STATE OF RHODE ISLAND AND PROVIDENCE PLANTATION
DEPARTMENT OF TRANSPORTATION
RHODE ISLAND CONTRACT NO. 2014-CB-004

Improvements to I-195
Accelerated Bridge Construction (ABC) of
Bridge No. 465 Replacement
I-195 Ramp (DR-2) over Warren Avenue

ADDENDUM NO. 3:

WINGWALL SECTIONS

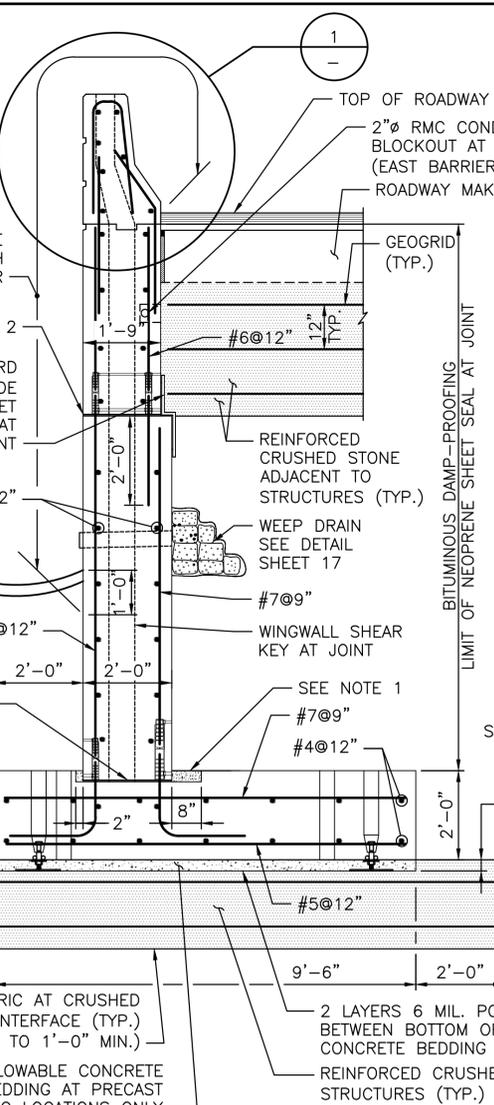
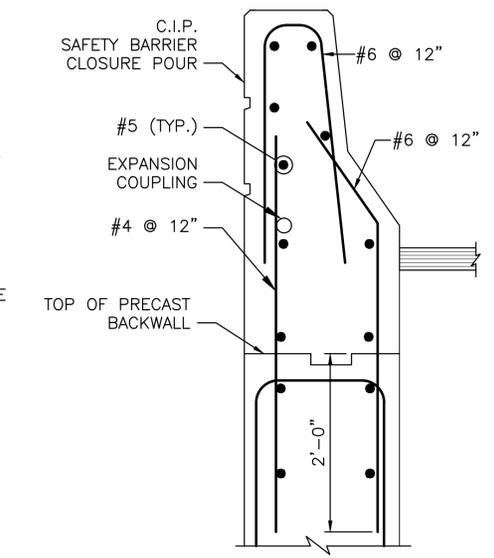
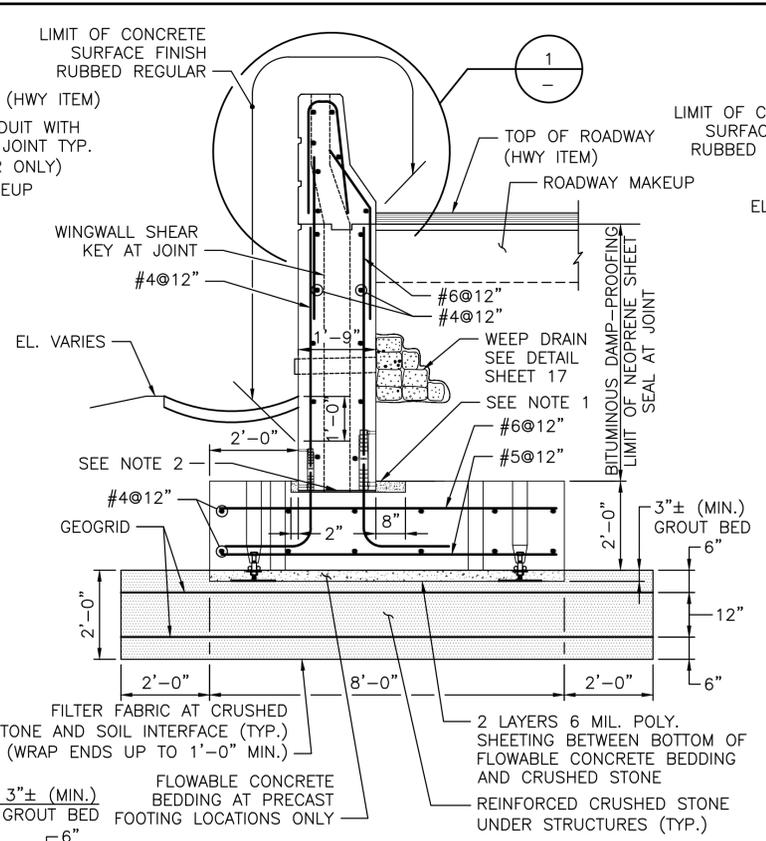
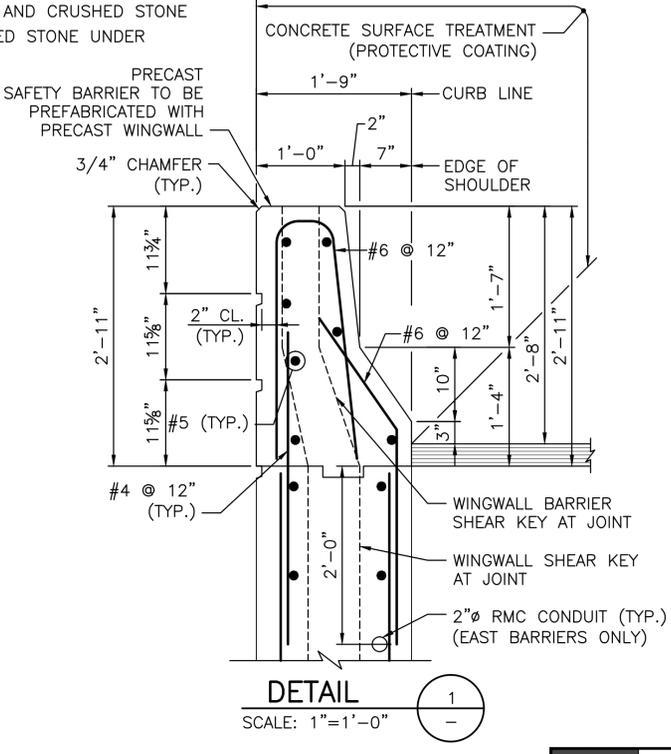
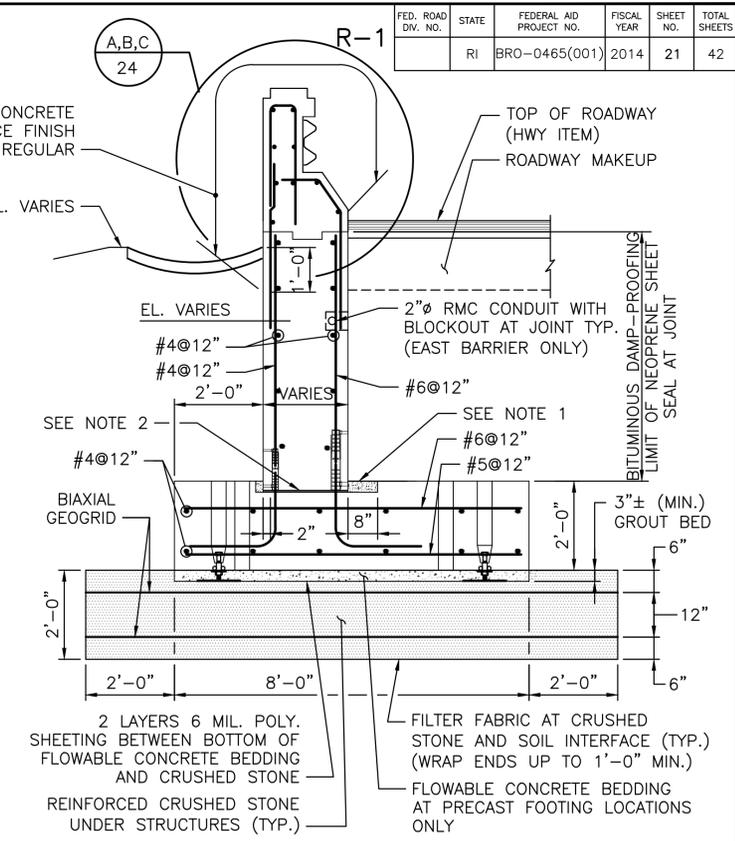
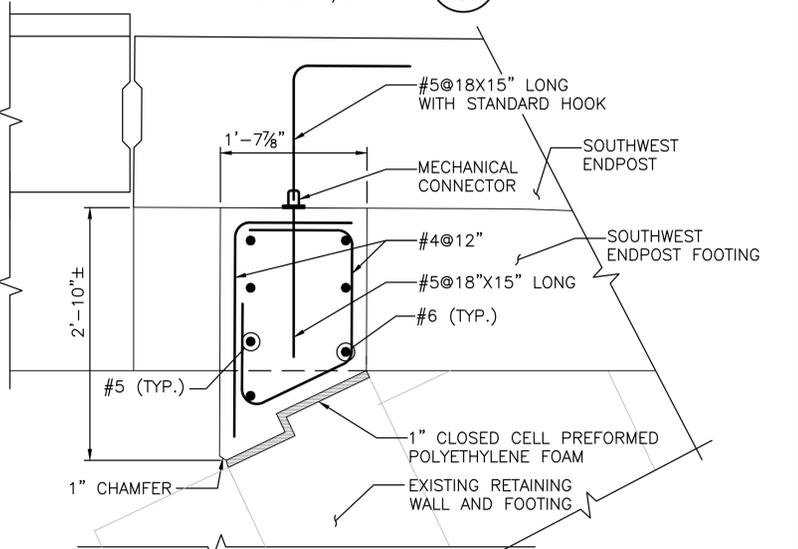
1. VOLUME 2 SHEET 5 OF 42 – GENERAL BRIDGE NOTES SHEET 3 OF 3
Delete Sheet 5 (R1) in its entirety and replace it with Sheet 5 (R2) attached to this Addendum No. 3. This sheet has been revised.
2. VOLUME 2 SHEET 21 OF 42 – WINGWALL SECTIONS
Delete Sheet 21 in its entirety and replace it with Sheet 21 (R1) attached to this Addendum No. 3. This sheet has been revised.
